PLANNING COMMISSION AGENDA

a. 340 N. Center - Commercial/Residential Building

**Re: 340 Center Street
City of Northville, Wayne County, Michigan
Site Plan Review**

**Combined Preliminary & Final Site Plan Review
For
City of Northville, Michigan**

TRASH ENCLOSURE

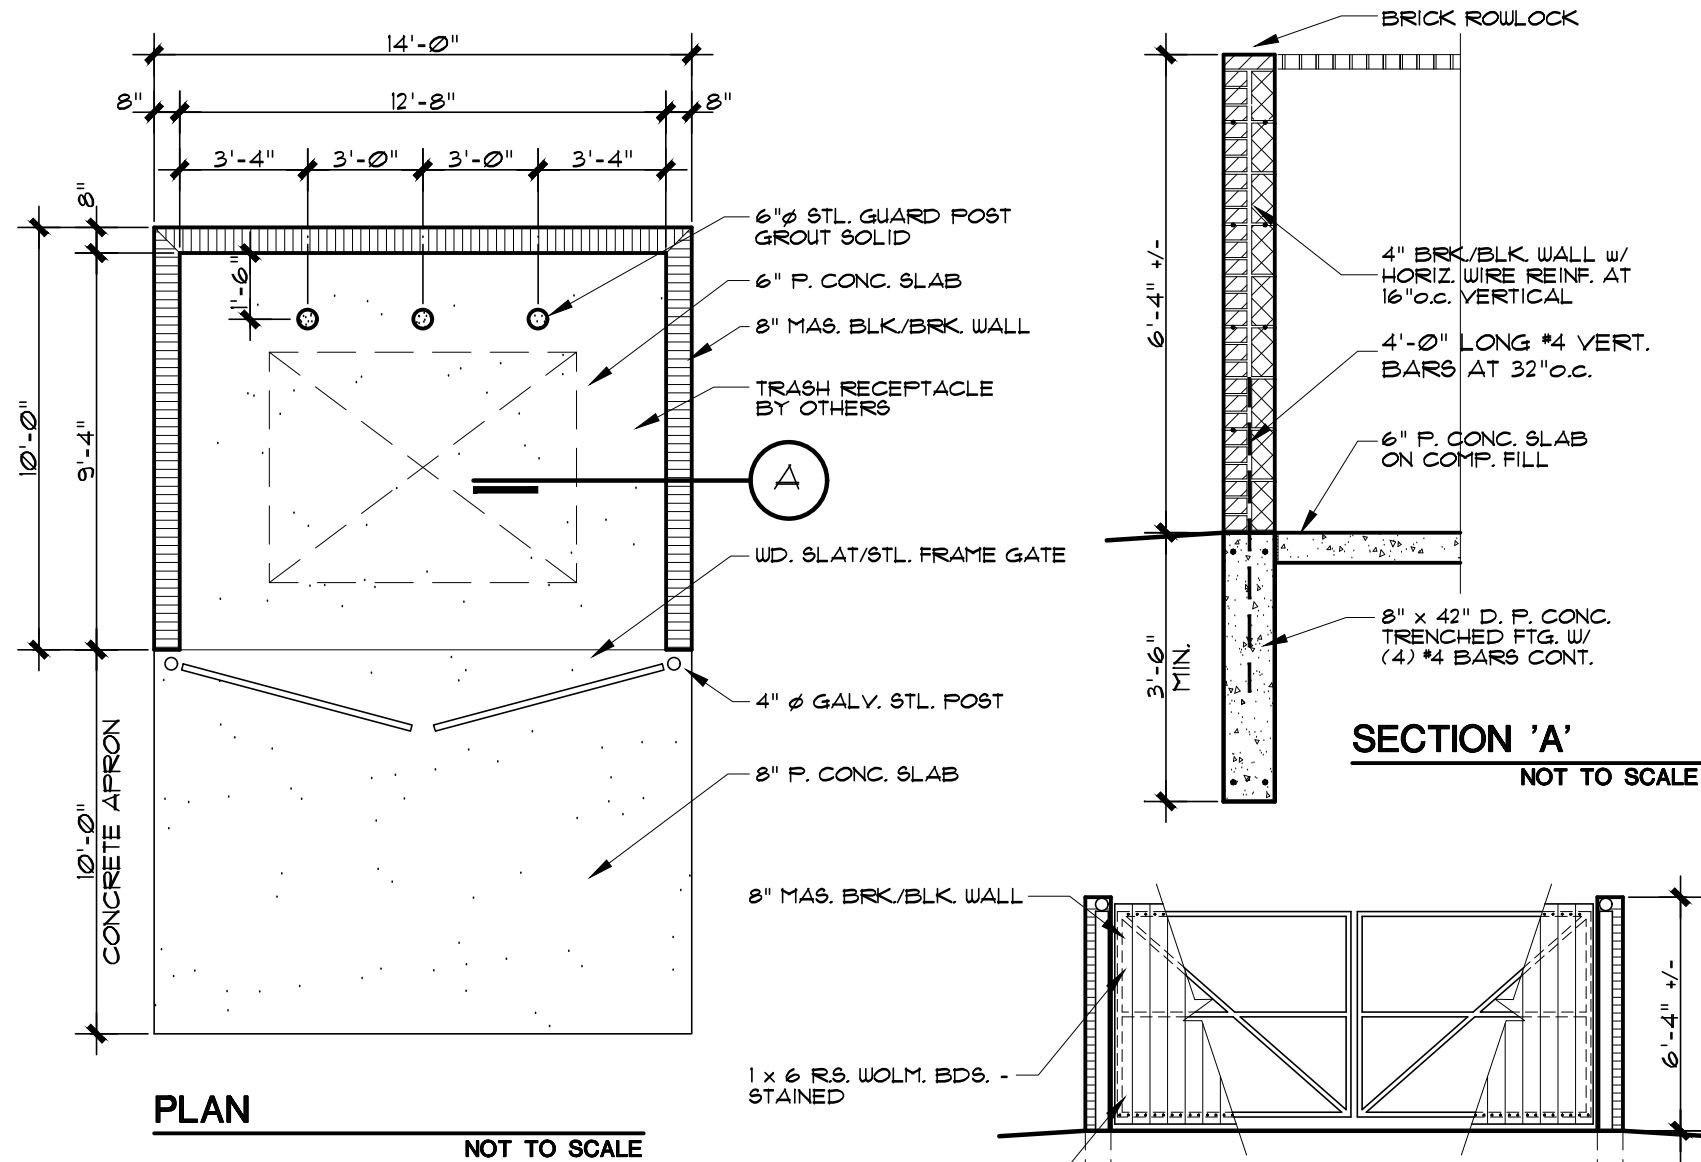
The site plan indicates that a dumpster and screen will be located in the southeast corner of the parking lot (or rear yard, as required). A detail of the screen wall is provided on Sheet SP-1, showing a block wall faced with brick, which will complement the proposed brick façade of the building.

SHEET
General Site Plan

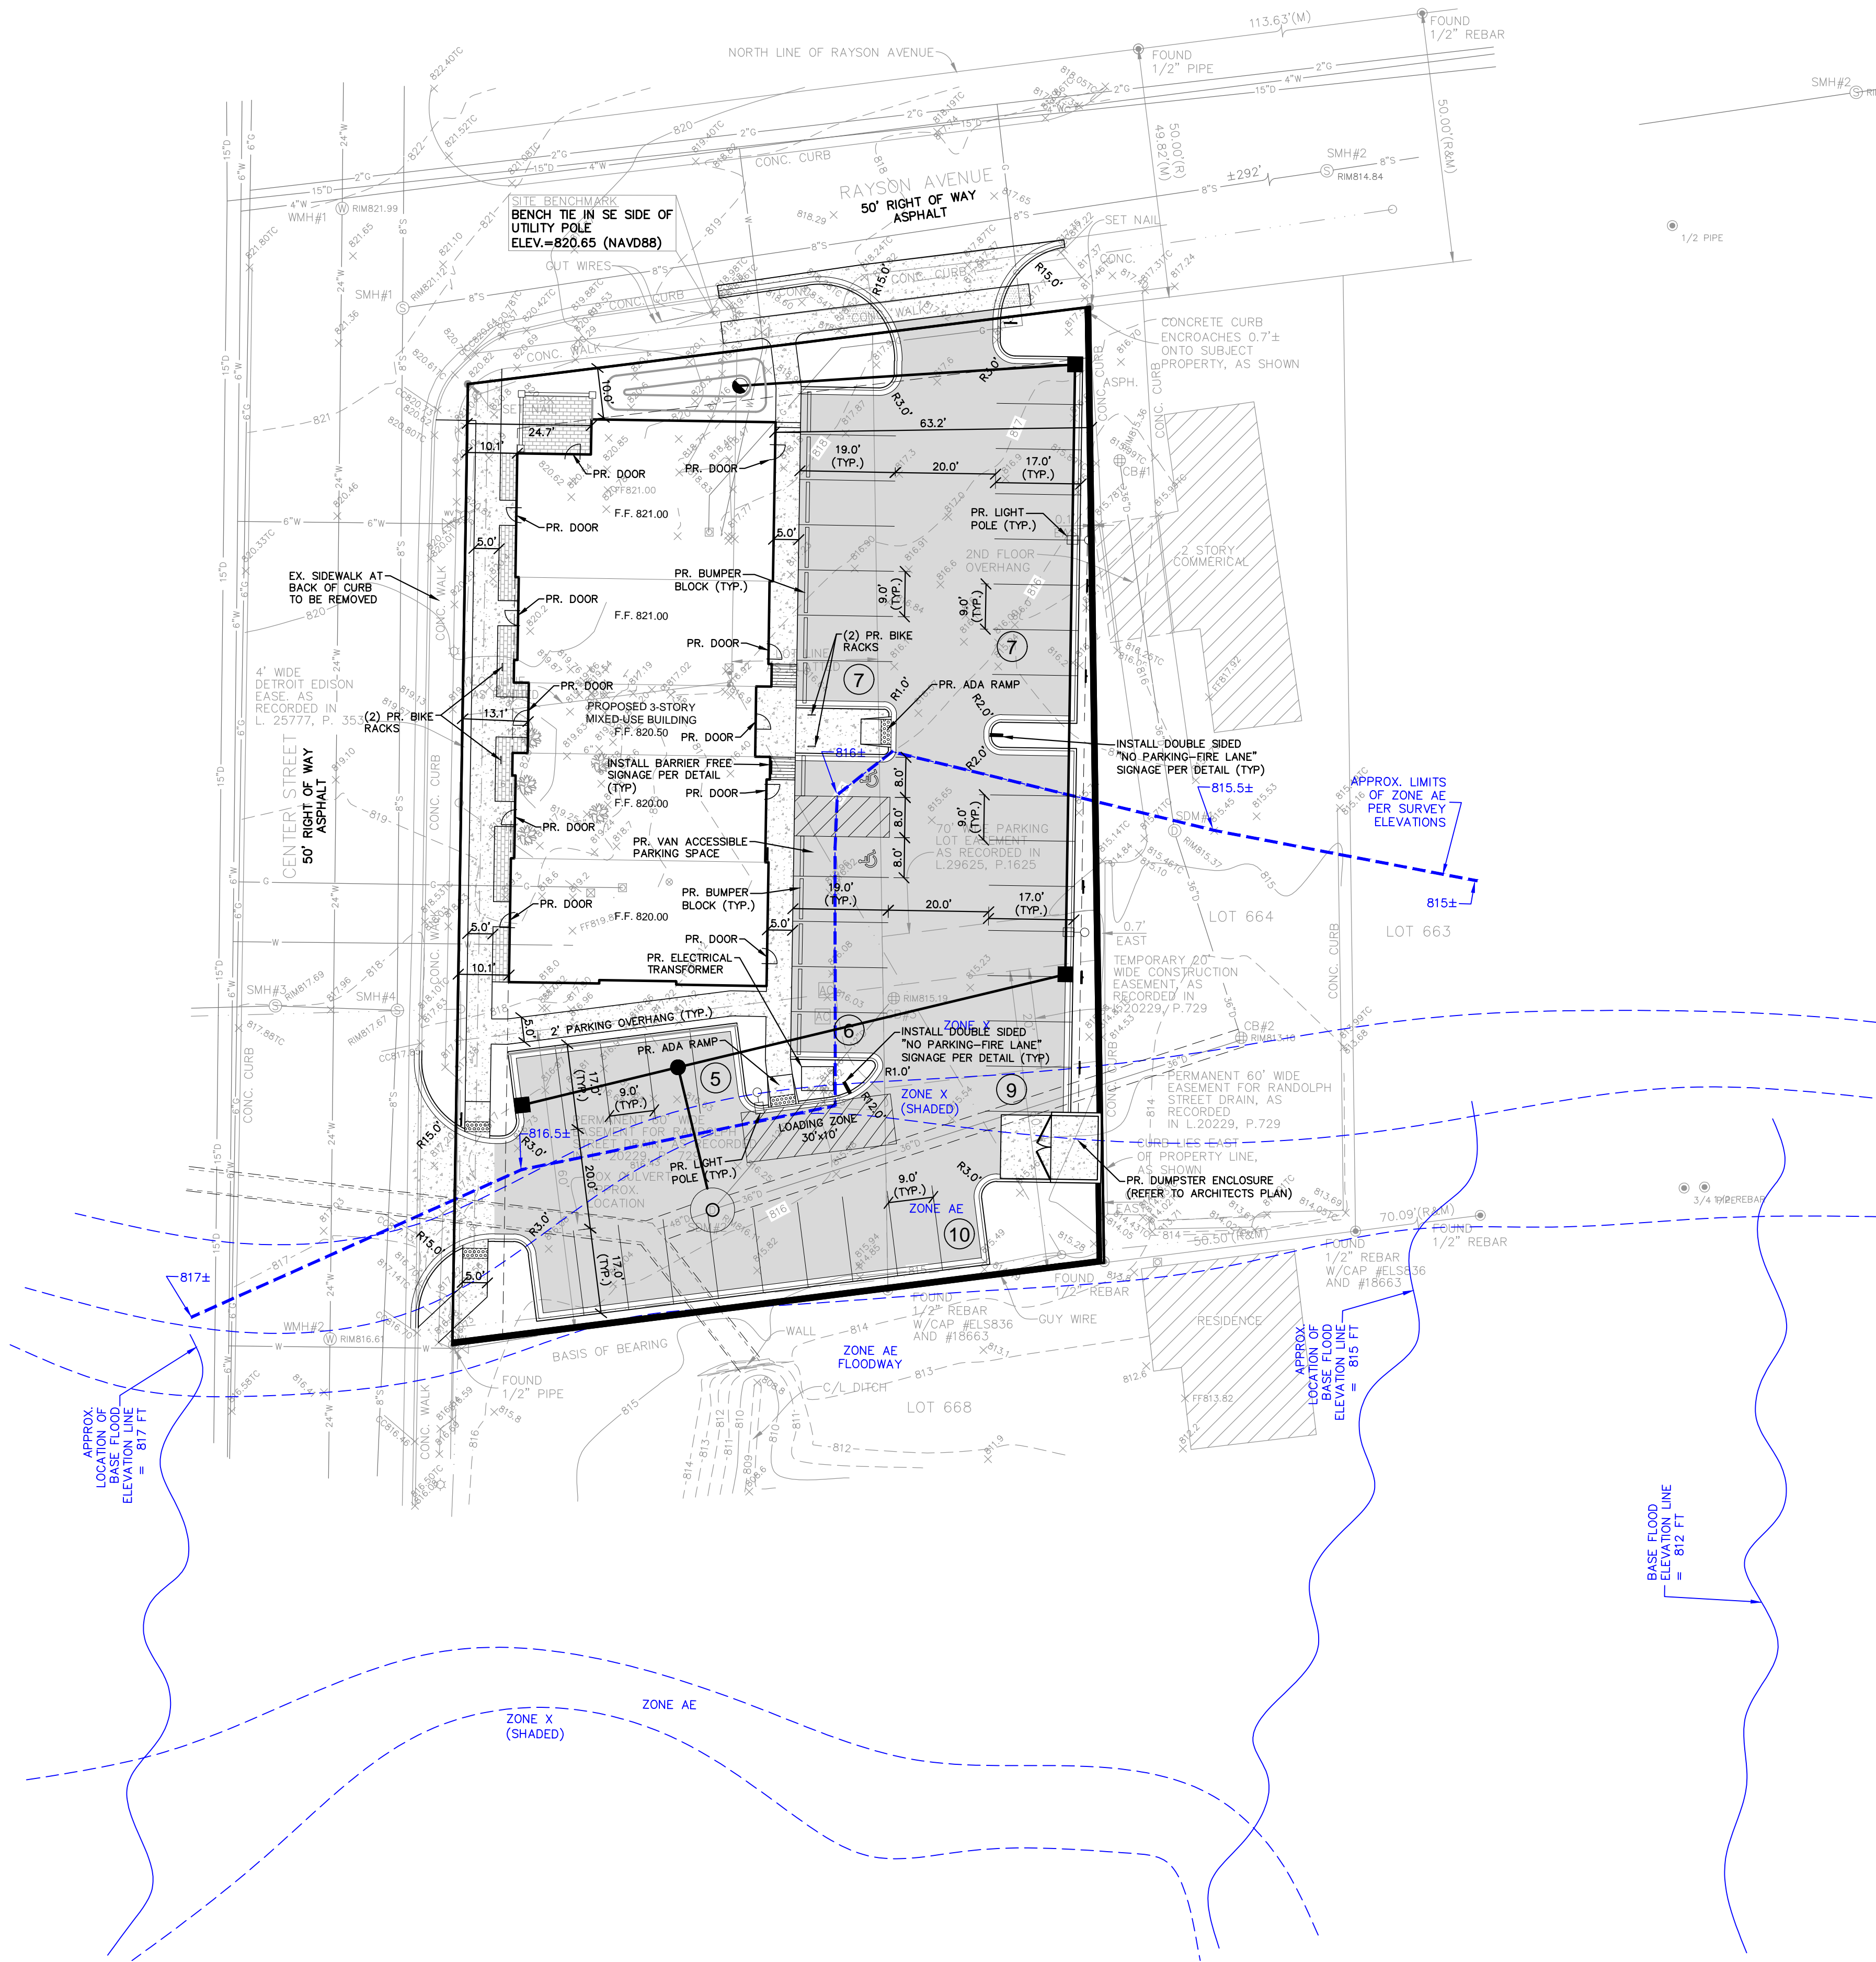
Sheet SP02, *General Site Plan*, shows information about the Randolph Street Drain floodplain. It identifies the floodplain as illustrated on the Federal Emergency Management Agency (FEMA) map below:

This sheet also identifies the floodplain per survey elevations between 815 and 817. The finished floor of the proposed building is at an elevation of 820, and therefore out of the flood prone areas. We defer review of all improvements in the 100-year flood plain to the City Engineer during the engineering review stage.

Circulation of a garbage truck is shown on Sheet SP02.1. The plan shows that a garbage truck can access and maneuver on the site. Interaction with the loading/unloading zone clearly shows that garbage pick up will need to be coordinated during off-hours for the commercial businesses.
